INSTITUT LUXEMBOURGEOIS
DE RÉGULATION

OBSERVATIONS TRANSMISES

**DANS LE CADRE DE LA CONSULTATION PUBLIQUE DU 30 MAI 2025 AU 08 JUILLET 2025
PORTANT SUR L'ÉVALUATION DE LA CONTRIBUTION POTENTIELLE DE L'INFRASTRUCTURE DE CHARGE À
LA FLEXIBILITÉ, À L'AUGMENTATION DE LA PART D'ÉLECTRICITÉ RENOUVELABLE ET À LA RÉDUCTION DES
COÛTS POUR LE SYSTÈME ÉLECTRIQUE.**

Creos Response to the Public Consultation by ILR on the *Contribution of Electric Vehicle Chargepoints to the Flexibility of the Luxembourgish Energy System and the Absorption of Renewable Energy*

Figure 2 – Projected electricity demand during the evening peak according to updated Scenario Report version 2024 (Figure 8.2 on page 113)

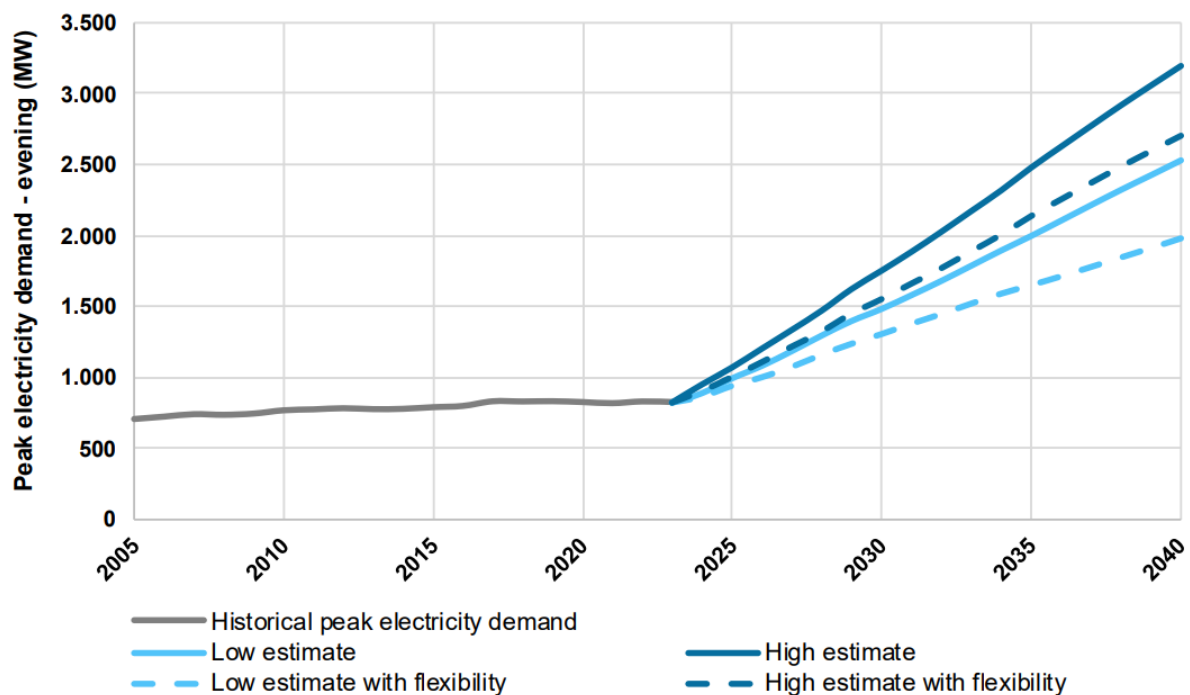
In Table 18 (page 41) of the Cenex report, an annual peak demand forecast of only 860 MW for 2030 is referenced, derived from the soon-to-be-updated Creos Scenario Report of 2023. This Creos Scenario Report presents several forecast scenarios (page

84), each varying significantly based on their underlying assumptions—such as using the "target" or "reference" NECP scenarios and the inclusion or exclusion of flexibility considerations. The specific demand scenario utilized for the optimization in the Cenex report is not explicitly stated; however, the cited figure of 860 MW suggests it corresponds to a lower-end estimate. Using this low estimate significantly influences the optimization results to the point that the adoption of a more realistic scenario from the same report would easily increase peak load estimates by several 100 MW resulting in significantly less network deferral savings. Moreover, recent governmental adjustments of the NECP indicate further increases, highlighting the overly optimistic nature of the chosen scenario and thus overstating potential grid reinforcement deferral. This is also reflected in the recently published [Scenario Report \(version 2024\)](#) by Creos where the projected evening peak demand is estimated to range between 1484 MW (low estimate) and 1751 MW (high estimate) by 2030 (Figure 2) largely exceeding the numbers used in the Cenex report.

- Integrate realistic 2030 demand forecasts aligned with current governmental energy targets and revisions.
- Include realistic alternative EV plug-in behaviour patterns into the network deferral simulations.
